KURNOOL CEMETERY

Expressing the displeasure of Government with those concerned in the selection of a new site for the --, and directing the Collector of Kurnool to select another site.

No. 88, ECCLESIASTICAL, 23RD NOVEMBER 1895.

NEW CEMETRY WEST OF KURNOOL

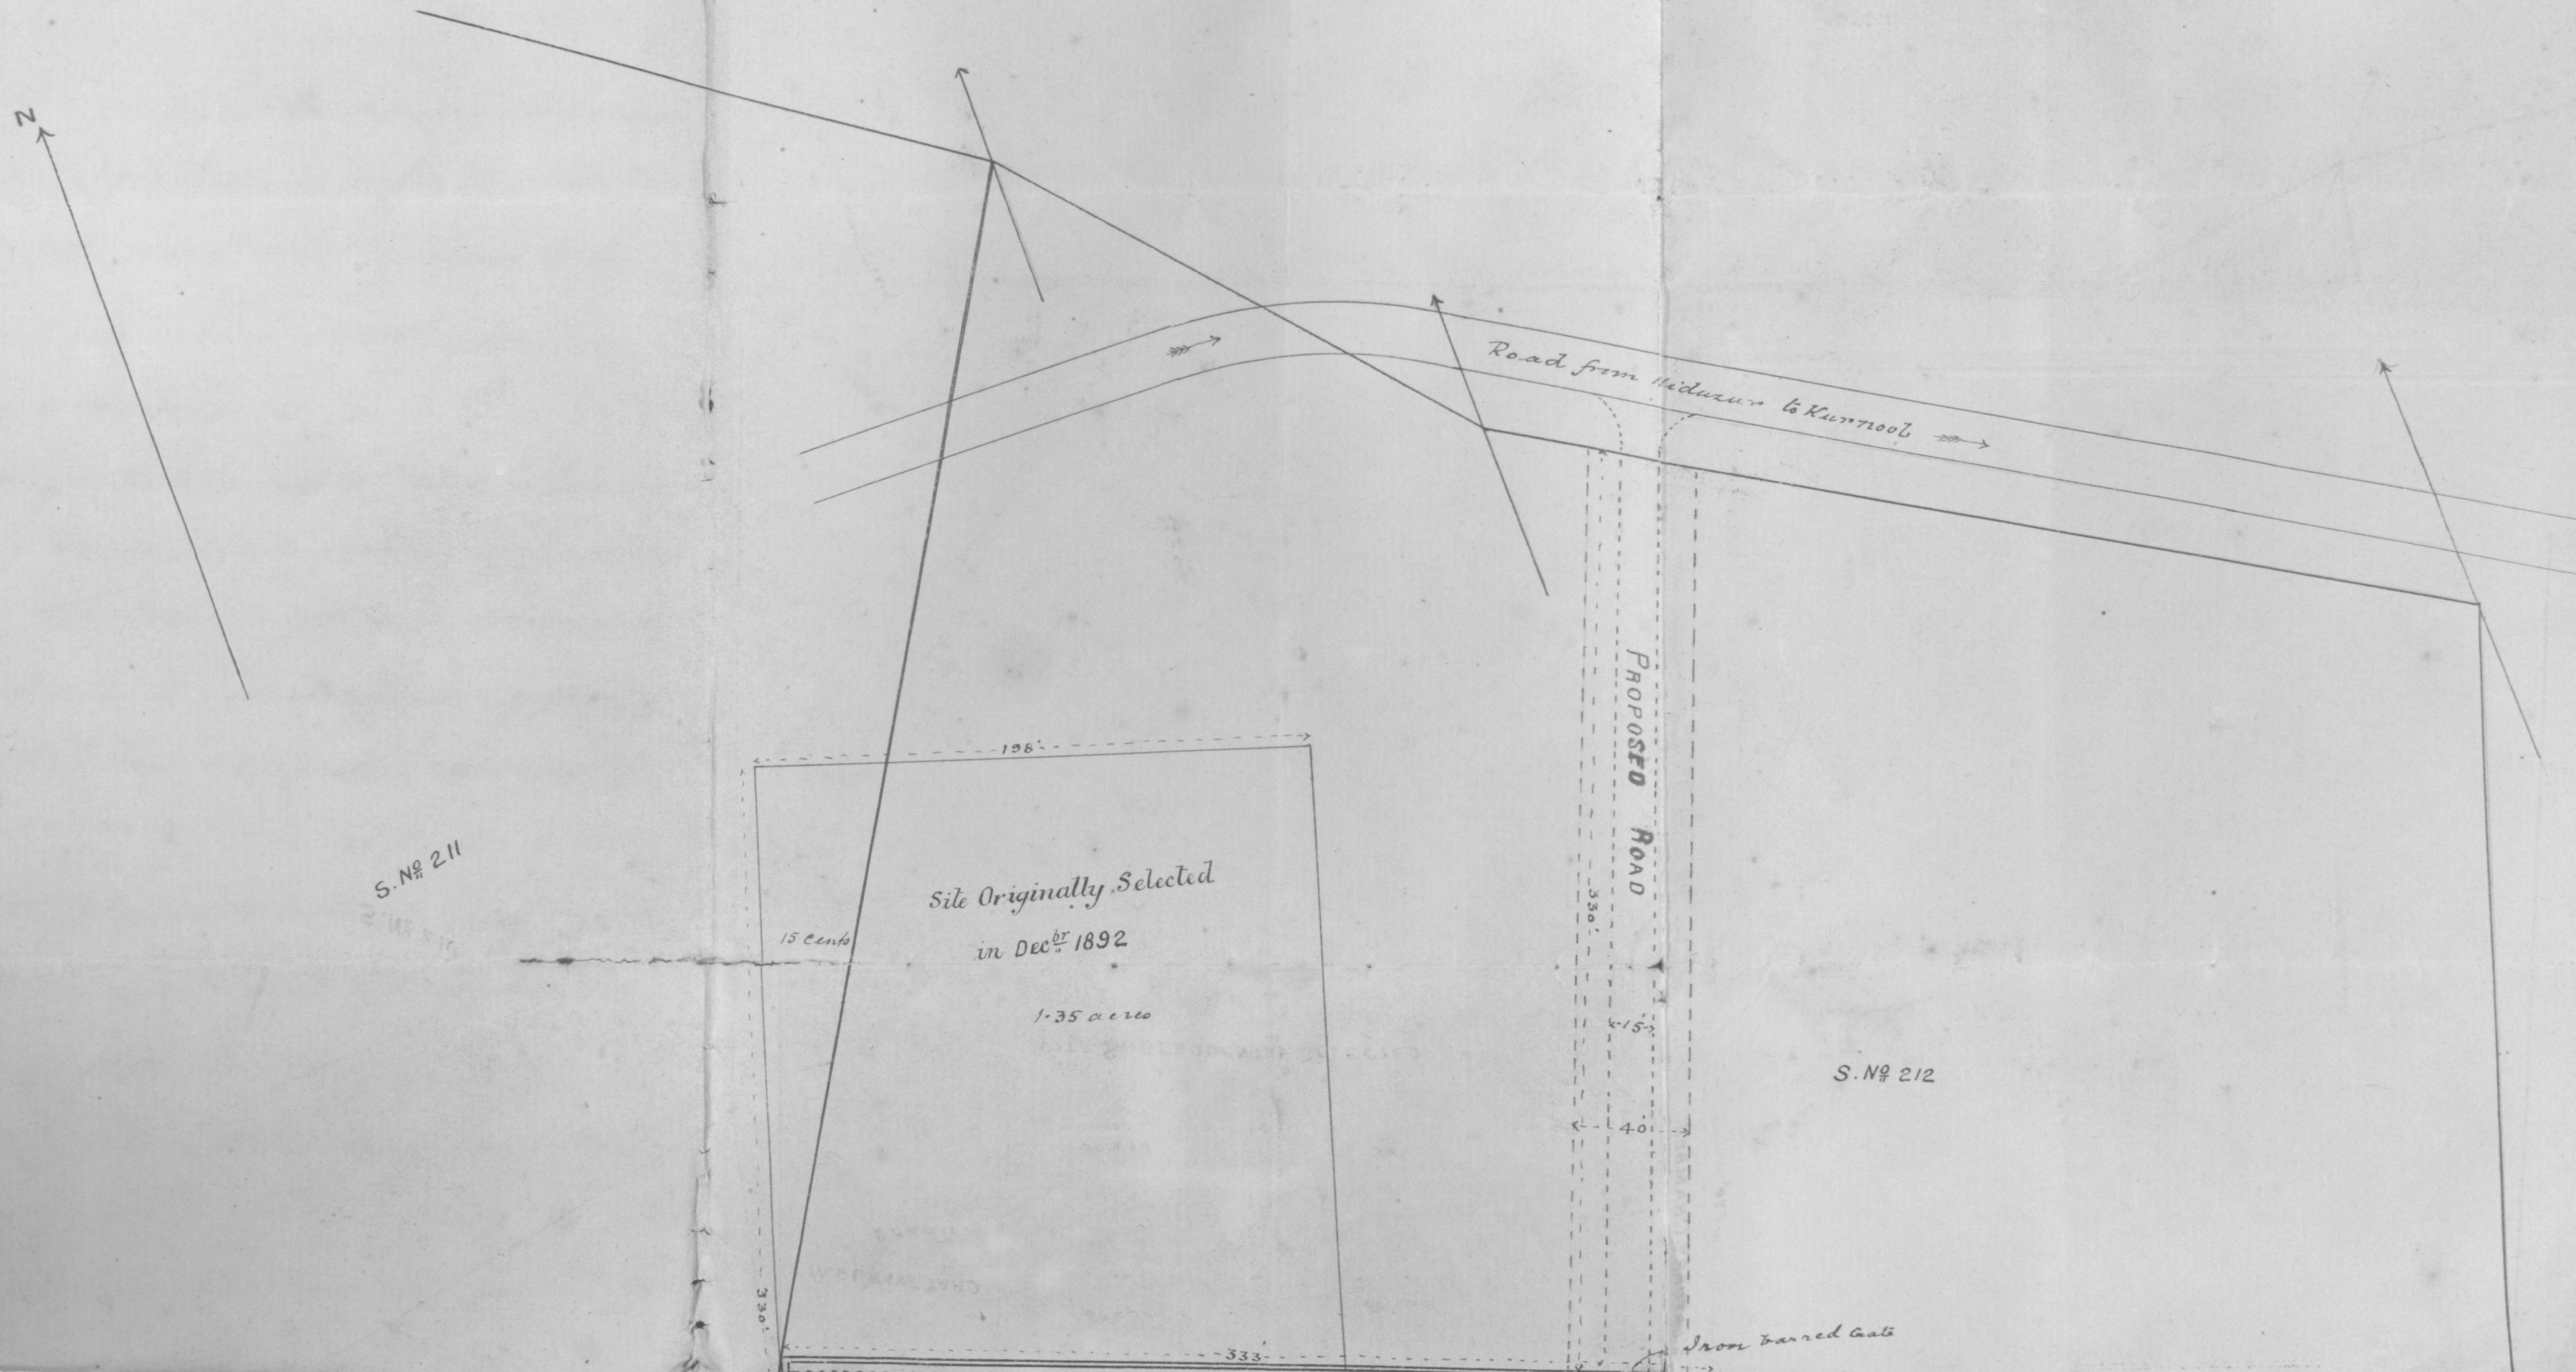
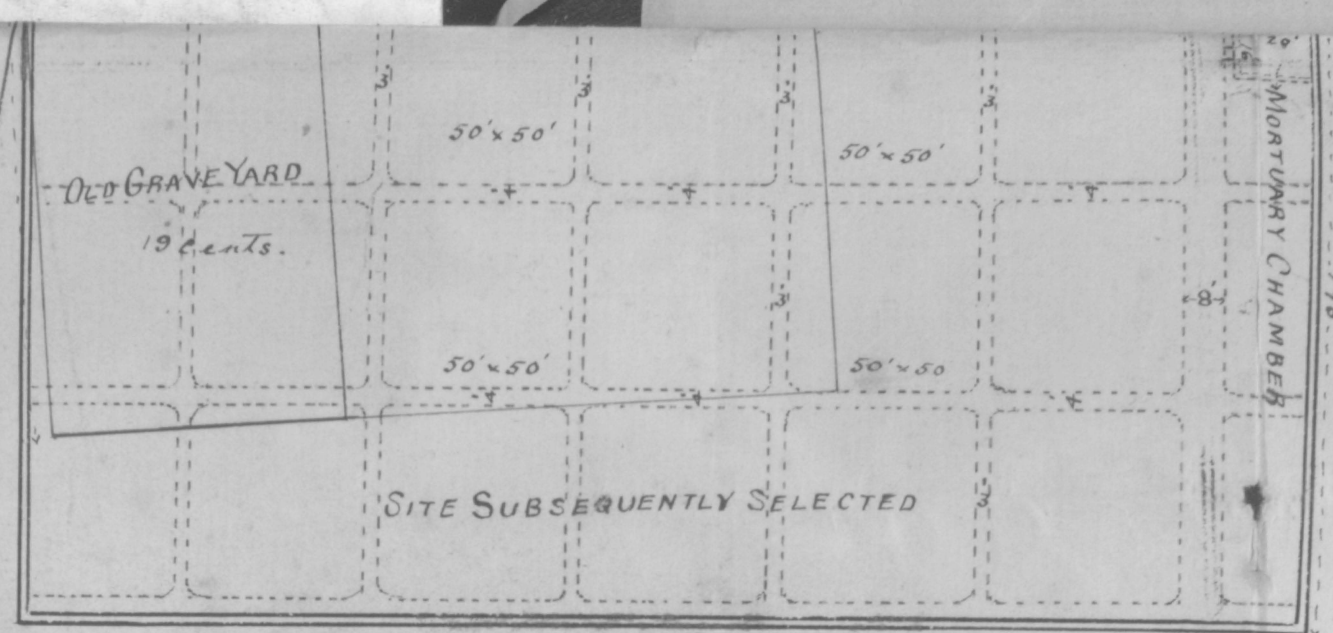
2. The place appears to be quite unsuitable for use as a cemetery as it is a bed of hard slate covered by black-cotton soil to the depth of only two or three feet. I enclose for reference a plan showing numerous trial pits dug under the direction of the Executive Engineer. The greatest depth of soil is 3' 9" and the shallowest 1' 3". Out of fourteen trial pits dug, only four show a depth of 3'.

4. No. 2 is indicated on the plan by red lines, and No. 3 by firm blue lines. It is No. 3 on which Rs. 1,712-9-3 have been expended, in which the fourteen trial pits shown in the accompanying sketch have now been dug and which has been condemned by Mr. Thorburn and Mr. Tate—*vide* latter's letter, Dis. No. 838-Eng., of 1895, dated 10th May 1895, read in Government memorandum, No. 1106, dated 22nd May 1895. Its extent is just the same as that of No. 2, but an additional piece of 14 cents of land has been taken up for constructing a road leading to the cemetery from the nearest adjoining road, the Kurnool-Nidzur famine road.

3. It seems clear that the Executive Engineer was aware that a certain depth of soil was necessary, for he remarked that at least 4 feet was obtainable at one end of the new site. It seems further evident that he did not at the time test the depth in other parts, and apparently he completely overlooked this *sine qua non* afterwards, for the trial pits which have since been sunk show depths varying from $3\frac{3}{4}$ to $1\frac{1}{4}$ feet over a great portion of the site.

5. This negligence on Mr. Mullaly's part is viewed by Government with dissatisfaction. He will select a suitable site for a cemetery without delay. The Executive Engineer will be called upon, in the Public Works Department, to show cause why he should not make good the public funds which have been unnecessarily expended owing to his want of due care.
